Proposed Residential Development on
Land between Houghton Grange and The How
Houghton Road, Houghton
Application Ref: 23/00627/OUT

REVIEW OF APPLICANT'S LANDSCAPE AND VISUAL APPRAISAL(LVA)

Peter Radmall, M.A., B.Phil, CMLI

Houghton and Wyton Parish Council

Figure 4: Year 1 and Year 15 Visualizations for VP5

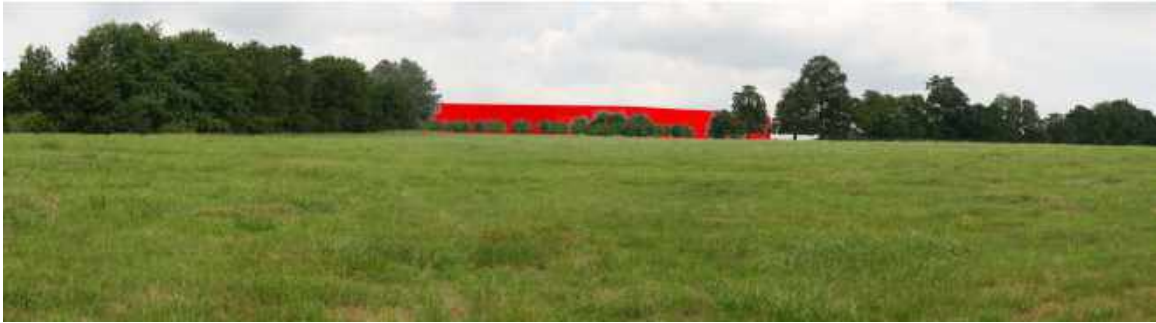
- 4.15 Scrutiny of the Y15 visualizations for VPs 5 and 6, however, suggests that this assumption should not necessarily be taken at face value. In relation to VP5, the Y1 visualization clearly shows what could legitimately be regarded as a major effect, with the development closing the skyline gap between the tree-belt within the site (to the right) and the trees within the Houghton Grange site (to the left). The Y15 visualization shows this gap to remain closed, with the development likely to remain visible beyond the proposed tree planting (and probably even more so in winter). This comparison is shown in **Figure 4** below.
